Form 3160-5
(June 2019)UNITED STATES
DEPARTMENT OF THE INTERIOR
BUREAU OF LAND MANAGEMENTFORM APPROVED
OMB No. 1004-0137
Expires: October 31, 2021**SUNDRY NOTICES AND REPORTS ON WELLS**
Do not use this form for proposals to drill or to re-enter an abandoned well. Use Form 3160-3 (APD) for such proposals.

8. Well Name and No. JEFE 29 FED COM/701H

EOG respectfully requests an amendment to our approved APD for this well to reflect the following changes:

Revised Permit Information 02/01/2022:

Proposed Wellbore

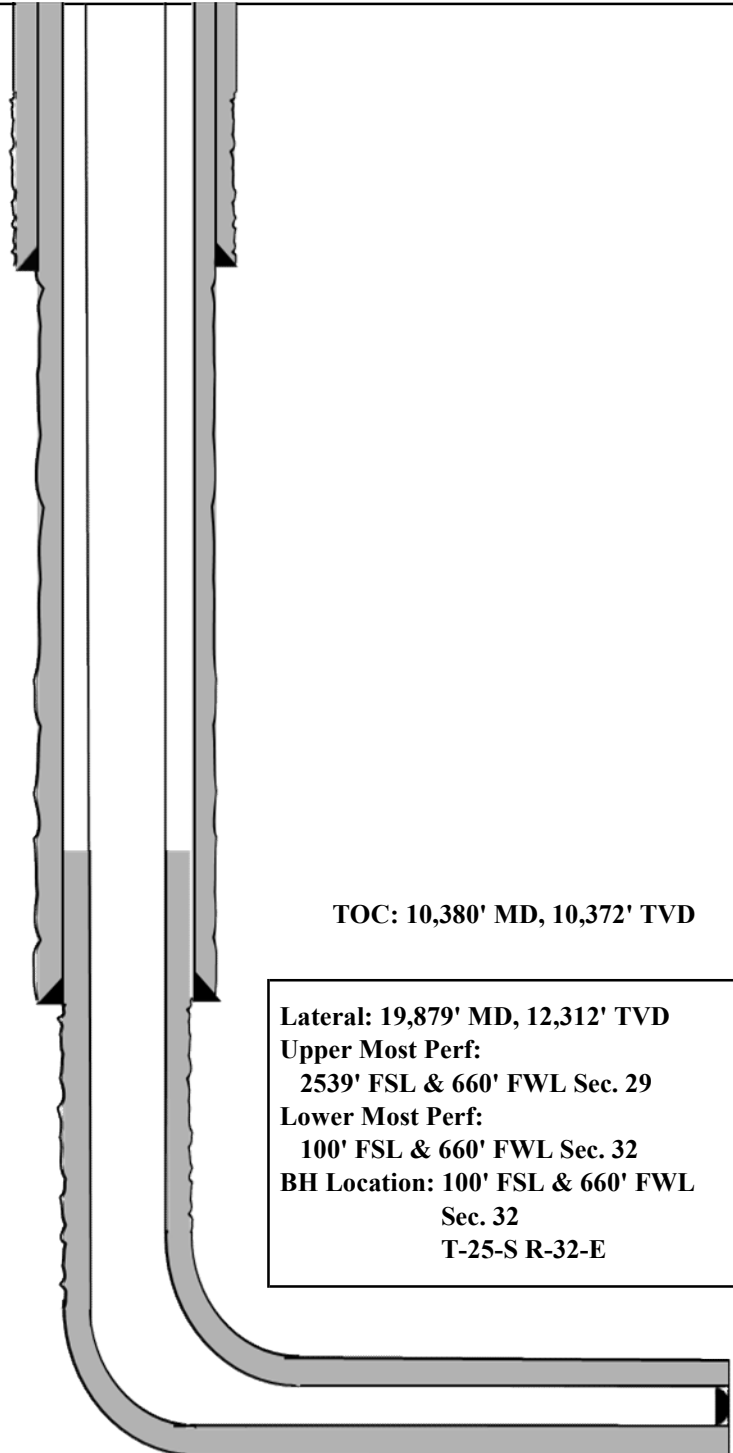
Design B**4. CASING PROGRAM**

Hole Size	Interval MD		Interval TVD		Csg OD	Weight	Grade	Conn
	From (ft)	To (ft)	From (ft)	To (ft)				
13"	0	1,150	0	1,150	10-3/4"	40.5#	J-55	STC
9-7/8"	0	10,880	0	10,872	8-3/4"	38.5#	P110-EC	Vam Sprint-SF
7-7/8"	0	19,879	0	12,312	6"	24#	P110-HP	Eagle SFH SC

Variance is requested to waive the centralizer requirements for the 8-3/4" casing in the 9-7/8" hole size. An expansion additive will be utilized, in the cement slurry, for the entire length of the 9-7/8" hole interval to maximize cement bond and zonal isolation.

Variance is also requested to waive any centralizer requirements for the 6" casing in the 7-7/8" hole size. An expansion additive will be utilized, in the cement slurry, for the entire length of the 7-7/8" hole interval to maximize cement bond and zonal isolation.

Variance is also requested to waive the annular clearance requirements for the 6" casing by 8-3/4" casing annulus to the proposed top of cement.

Figure 1: Cameron TA Plug and Offline Adapter Schematic

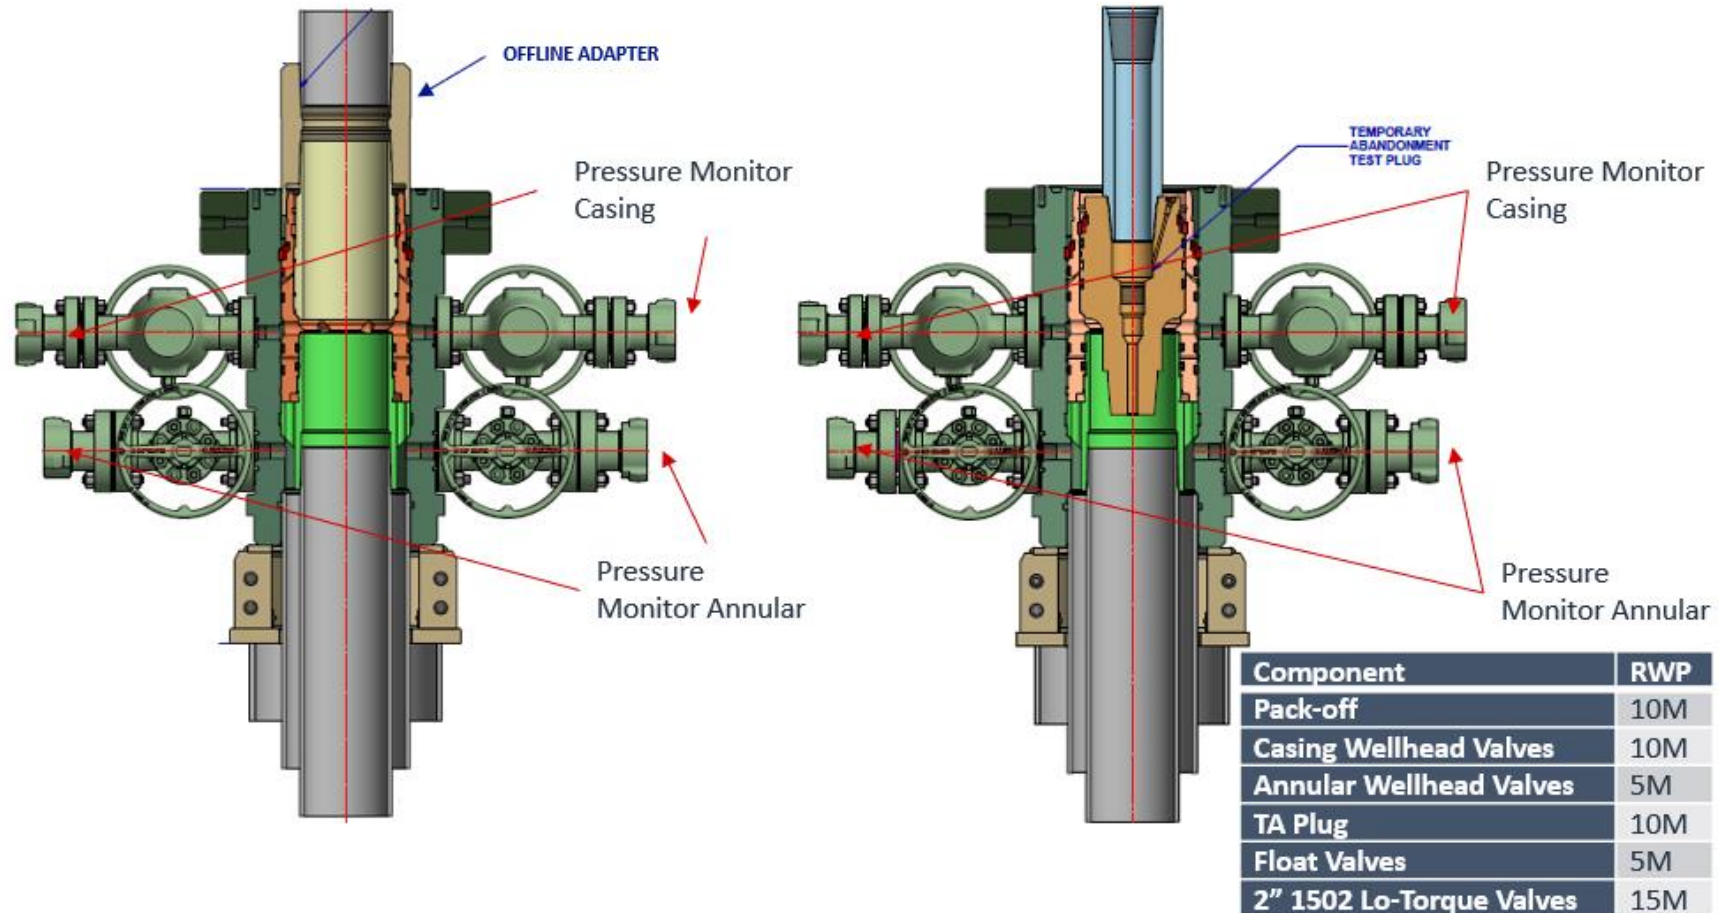
- c. Return line schematics can be seen in Figure 3.
10. Remove TA Plug from the casing.
11. Install offline cement tool.
 - a. Current offline cement tool schematics can be seen in Figure 1 (Cameron) and Figure 2 (Cactus).

Figure 4: Rig Placement Diagram

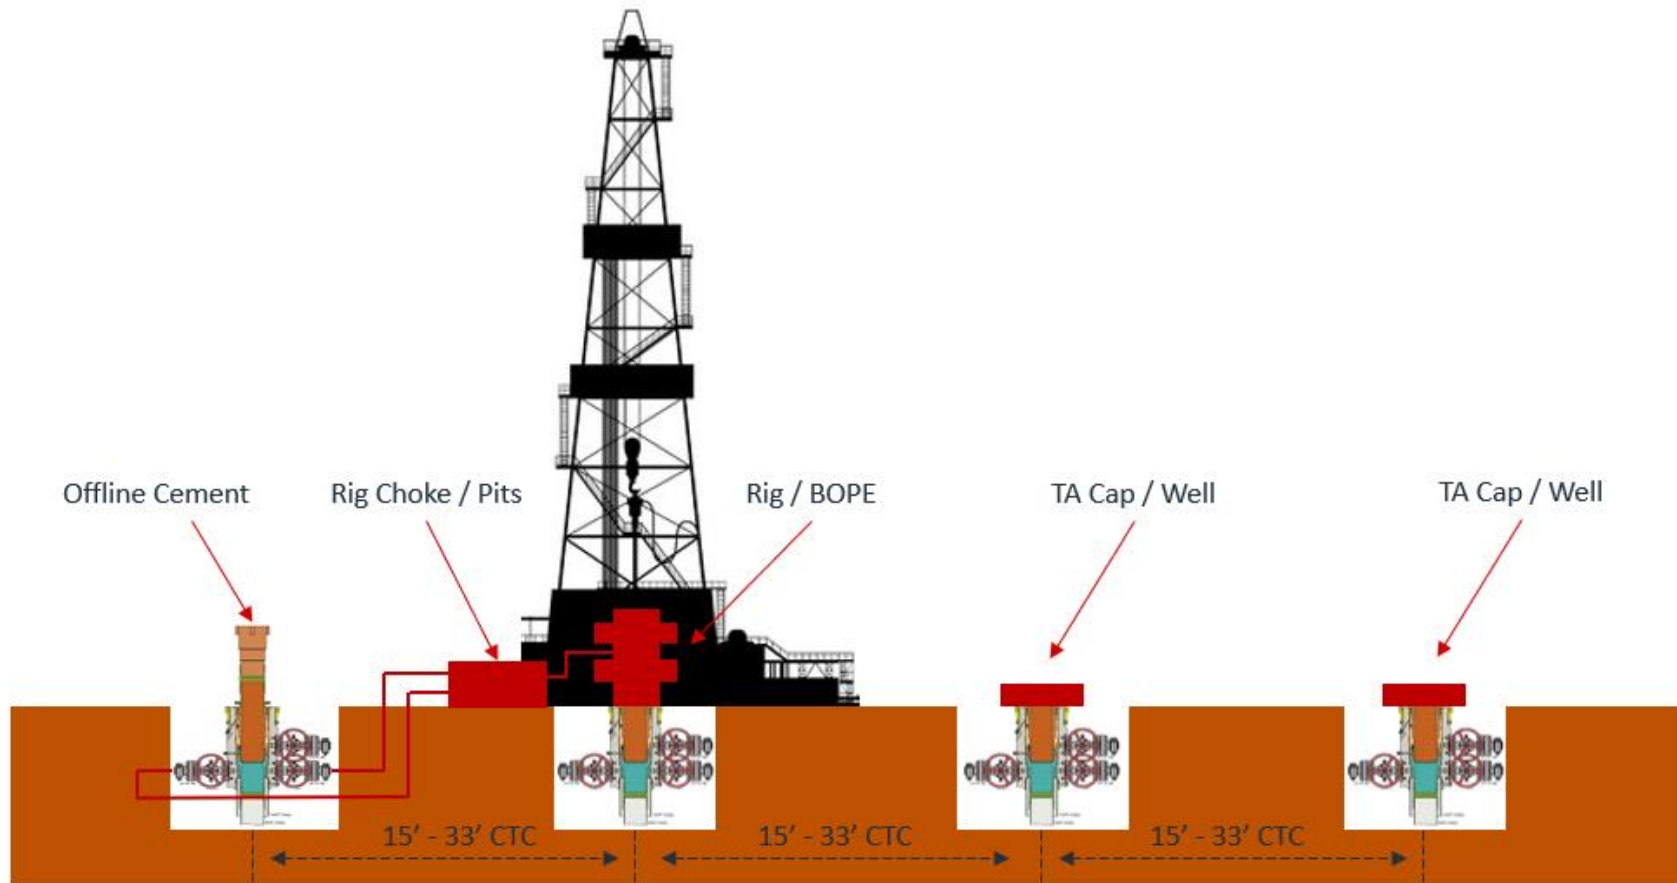
- e. Diagram for rig positioning relative to offline cementing can be seen in Figure 4.
9. Rig up return lines to take returns from wellhead to pits and rig choke.
